# GUARD RAIL TO BRIDGE RAIL TRANSITION

Vermont Agency of Transportation
RECEIVED
Clarendon BRO 1443(44) Approach Rail Submittal 3-10-16 3-22-2016.pdf

RESUBMIT Yes Rejected

SPECIAL PROVISION, GRAS - CONCRETE COMBINATION BR.
ROUTE NO. T.H. 3 (CLASS 2), RURAL COLLECTOR, BRIDGE # 11
TOWN OF CLARENDON, RUTAND COUNTY, VT.

SHEET 8 OF 12

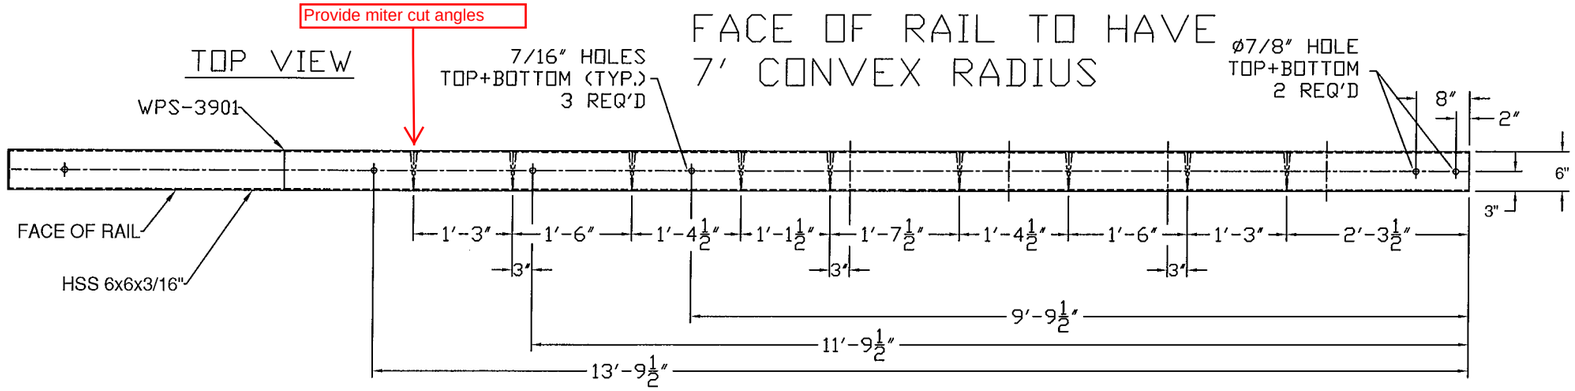
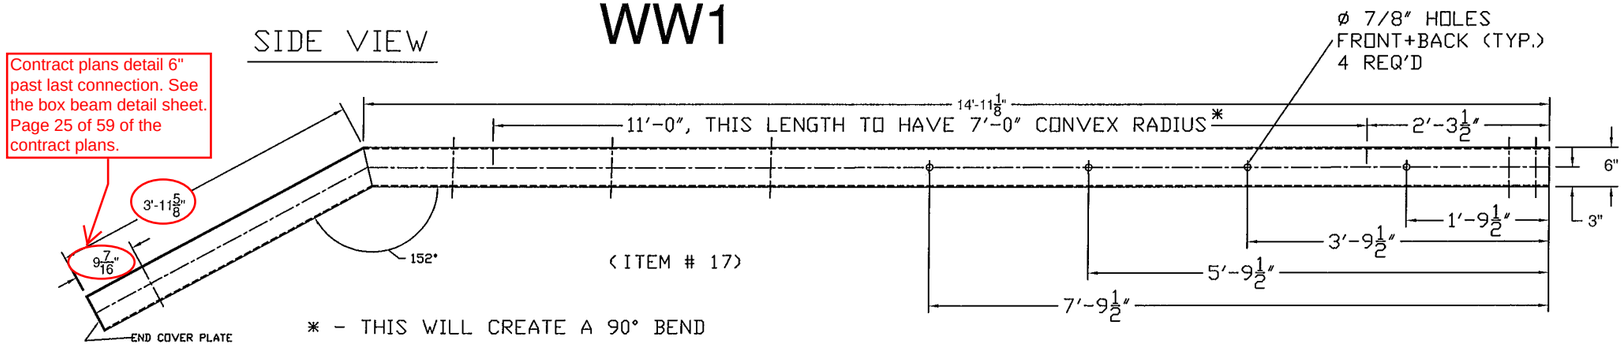
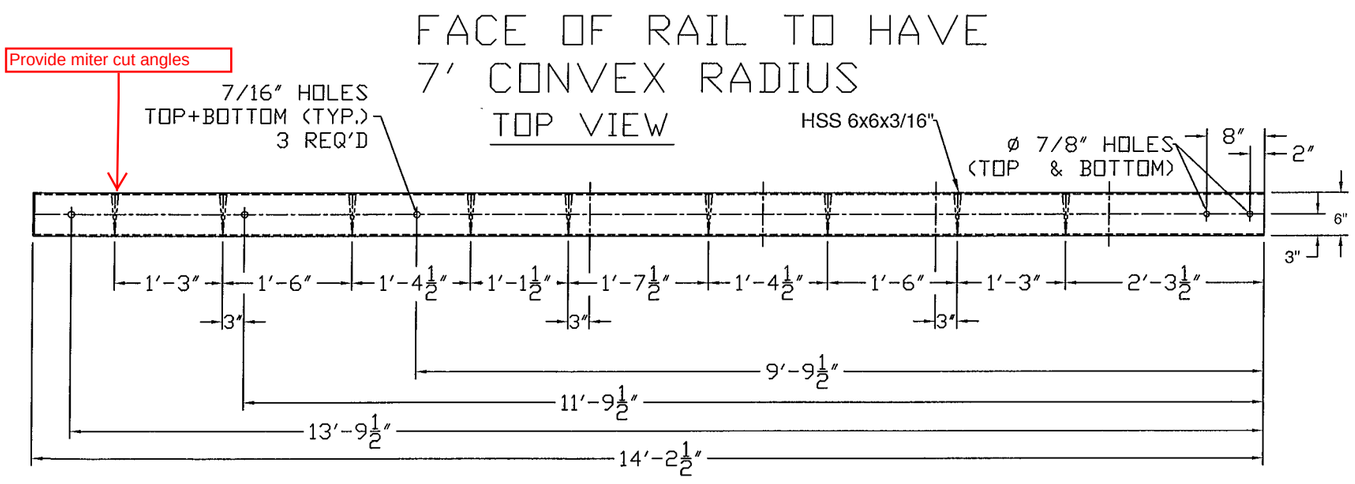
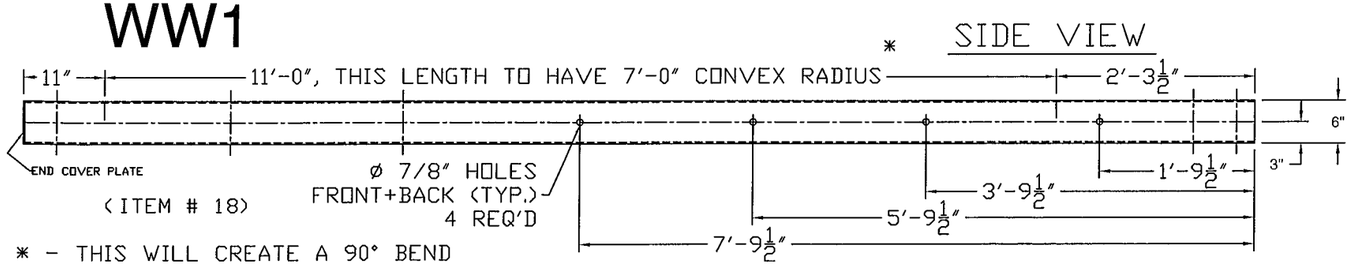
Provide miter cut angles

Are these pie cuts with welding? If so, this should be labeled and specify the WPS.

Contract plans detail 6" past last connection. See the box beam detail sheet. Page 25 of 59 of the contract plans.

Provide miter cut angles

Are these pie cuts with welding? If so, this should be labeled and specify the WPS.

Procedure No. 3900
Revision No.

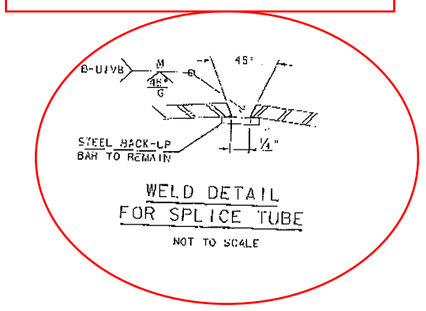
Not Legible. Looks like Machine finished inside tube? I don't think that's correct. Detail name doesn't seem to match D1.5 but I cant read it too well.

Should this be 279?

END COVER PLATE DETAIL

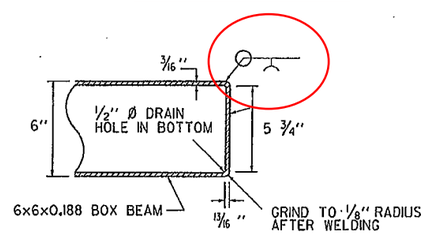
This is going to be a "U" groove weld??

Should this be 279?

Procedure No. 3026
Revision No.

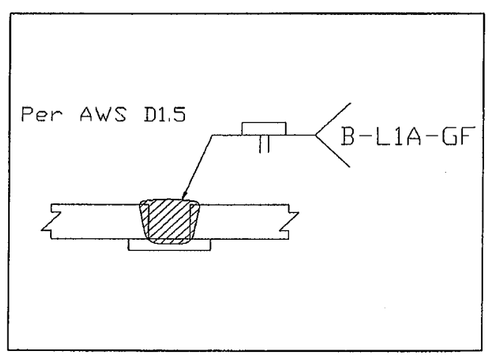
Should this be 279?
